GT Refresh Overview of Product Changes

GMI Sales Awareness 8th October 2020

GT Refresh – Part Number Updates

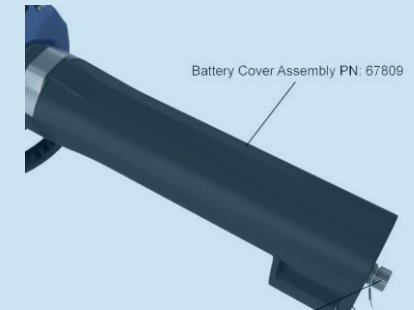
Front Cover

PN: 67806

(Was GT Fire part number)

Corrective Actions – Flexible probe fails

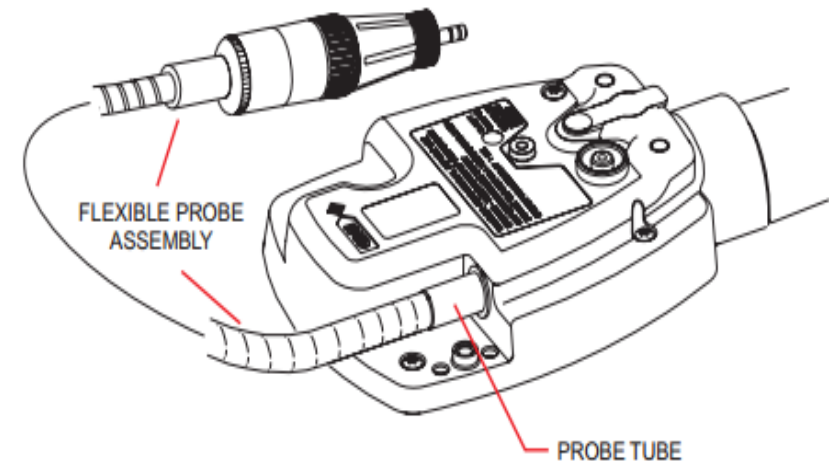
Loose probes, broken probe wires.

Probe held by a grub screw. Grub screw is not sufficient to hold the probe with repeated movement. Causes the probe to come loose and can cause the internal wires to break.

As part of maintenance regime probe glued in position on existing instruments

Corrective action: CN6363/6381

Probe glued in position on new builds.

A new spare rear assembly made with probe glued in position.

Corrective Actions - PSU

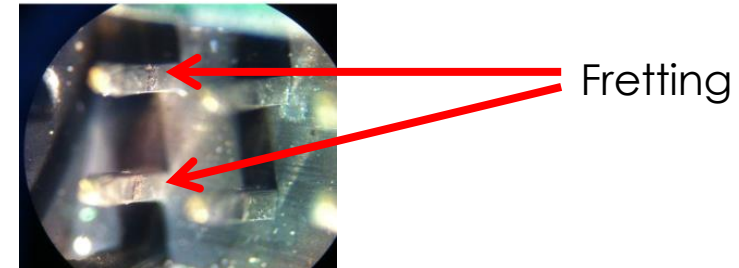
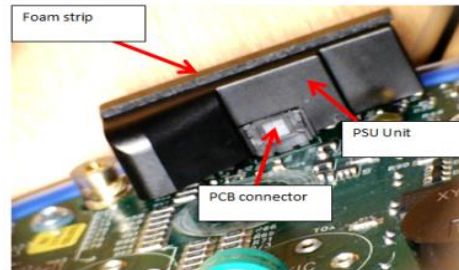
Various power failures would appear or disappear depending how tightly the housings were pressed or screwed together.

Signs of fretting between mating connectors of PSU.

Pump causing movements/vibrations resulting in fretting on tin plated contacts

PSU contact cleaning process implemented

Corrective action: CN6366

Gold connectors less prone to fretting. PSU connectors updated to gold plated parts. Implemented foam strip to immobilise the PSU.

Corrective Actions – Flammable gas range fails

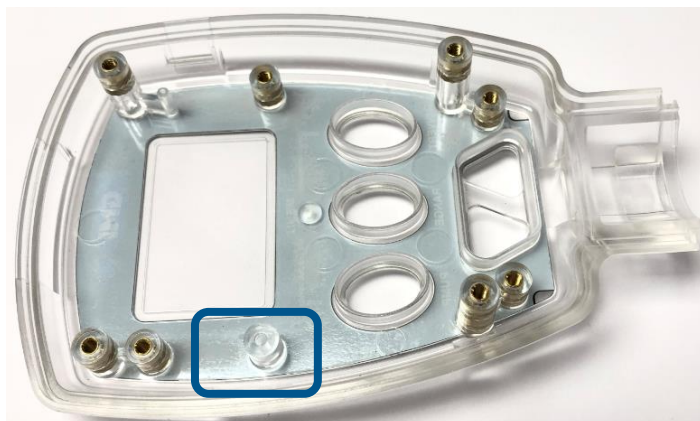
Bead Fault/Wrench on LEL range. The failure would appear or disappear depending how strongly the housings were pressed or screwed together.

Brass insert in position but is not needed. Brass insert was flush and could result in a short circuit across PCB tracks when the instrument is compressed/assembled.

The tracks at risk of being shorted are "BEAD SENSE" to GND. This would imply the sensor is faulty where it is not.

Corrective action: CN6390

Removed insert at position shown on below. **Implemented May 2014**

Corrective Actions – Pump fails

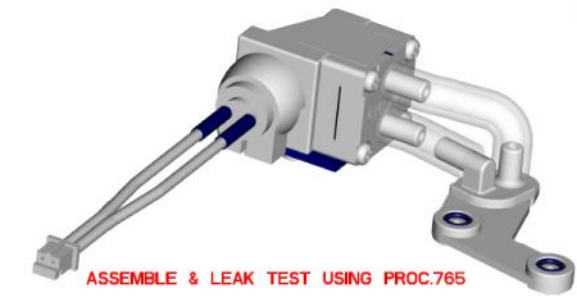
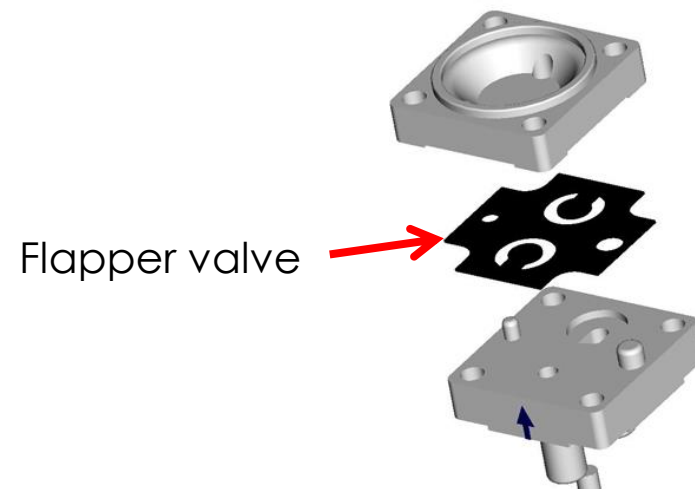
Variation in pump performance.

Rubber pump flapper valve is chlorinated. The chlorination is intended to make the rubber more robust. However, the chlorination process is not easily controlled, results in variation in the rubber flexibility affecting the pump performance.

- Pump flapper valve changed to unchlorinated material. Long term testing showed no deterioration in pump performance.
- Assembly methods reviewed.
- Production visual management tools implemented to monitor pump yield.
